Ref. No. 201512011 Petition No. 552

- (X) Involved; have no objection to the request for berm use (for parking only) into Joy Rd. at 14516 Joy Rd. as shown on drawing no. x552 dated 03-12-2015 provided that the following conditions are met with:

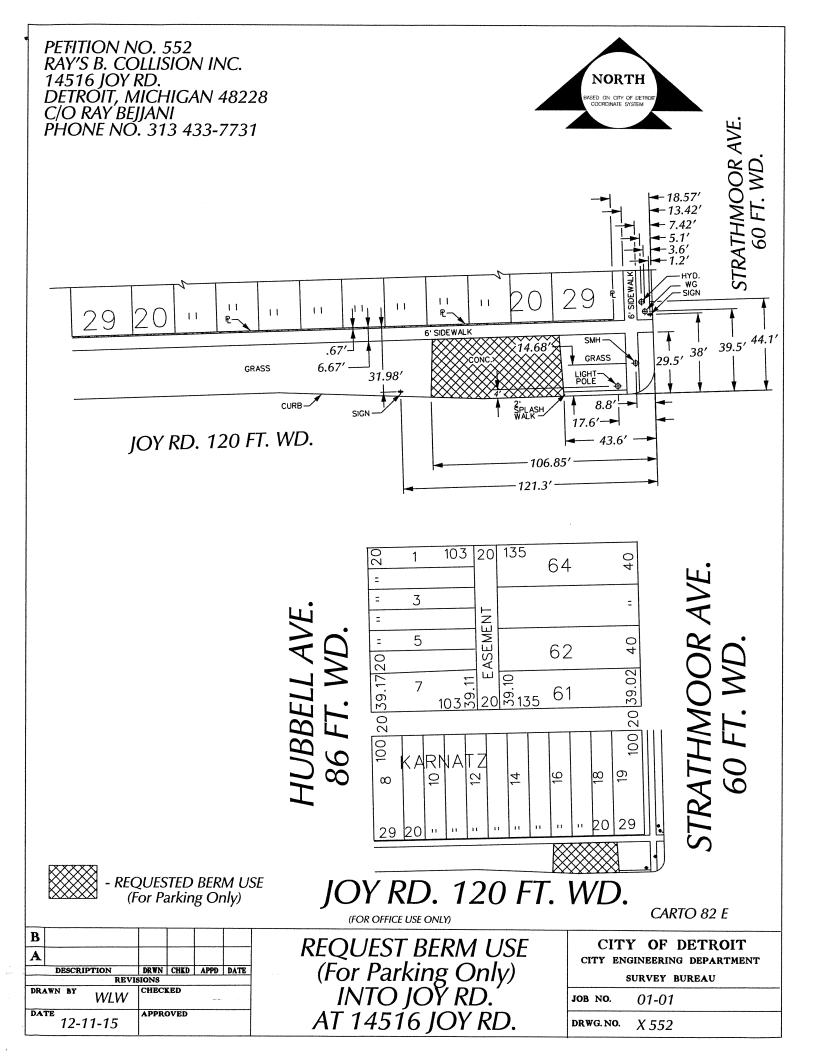
- (1) In order to delineate the parking area and to make it safe for pedestrian and vehicular traffic adjacent to it, the petitioner shall be responsible to install and maintain continuous concrete stoppers painted in yellow color along the edge of the concrete berm adjacent to the grassy area just west of it, along the edge of the sidewalk just north of it, and along the edge of the paved roadway just south of it as shown on the attached drawing.

- (2) It shall be the petitioner's responsibility to maintain at all times, a minimum 6 ft wide clear sidewalk in front of 14516 Joy Rd.
 - (3) Since this is a special case granting permission for berm use only for parking of employees' vehicles, the petitioner will be responsible to install a sign stating the same.
